# TECHNICAL BULLETIN

**MODEL/DERIVATIVE:**  
Discovery Series II

**Bulletin N°:** 0080  
**CDS. ref:** L8714bu  
**Issue:** 1  
**Date:** 31.10.01

**PROBLEM:**  
**FUEL FILLER FLAP DIFFICULT TO CLOSE**  
The fuel filler flap is difficult to close and / or will not stay closed.

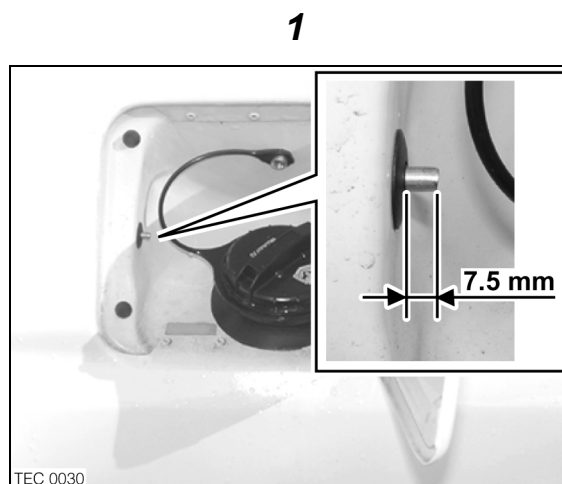
**CAUSE:**  
Fuel filler flap fouling against filler cap or damage to catch which prevents flap from latching correctly.

1. Release the fuel filler flap.
2. Release 2 bolts securing the fuel filler flap and remove flap.
3. Measure the actuator rod, it should be approximately 7.5 mm in length, (inset in illustration 1).
4. If the actuator rod is above / below the required length follow procedures 5 - 9.
5. Remove RH trim casing - side - loadspace, refer to Workshop Manual, Interior Trim Components, repair number 76.13.12.
6. Loosen actuator fixings and adjust the actuator to obtain the required length on the actuator rod.
7. If the actuator rod is still above / below the required length, release the actuator from fixings and disconnect actuator multiplug.
8. Elongate actuator fixing holes, repair paint finish as required. Where bare metal has been exposed, etch prime prior to painting.

9. Fit actuator, ensure actuator rod is at the required length, tighten fixing nuts and connect multiplug to actuator.
10. Paint the new fuel filler flap BPA000030.
11. Fit new fuel filler latch ALR6949 and cushion FSU000010 to fuel filler flap, (arrowed in illustration 2).
12. Position fuel filler flap to vehicle and tighten bolts.
13. Check operation of fuel filler flap and adjust if necessary.
14. Refit RH trim casing - side - loadspace, refer to Workshop Manual, Interior Trim Components, repair number 76.13.12.
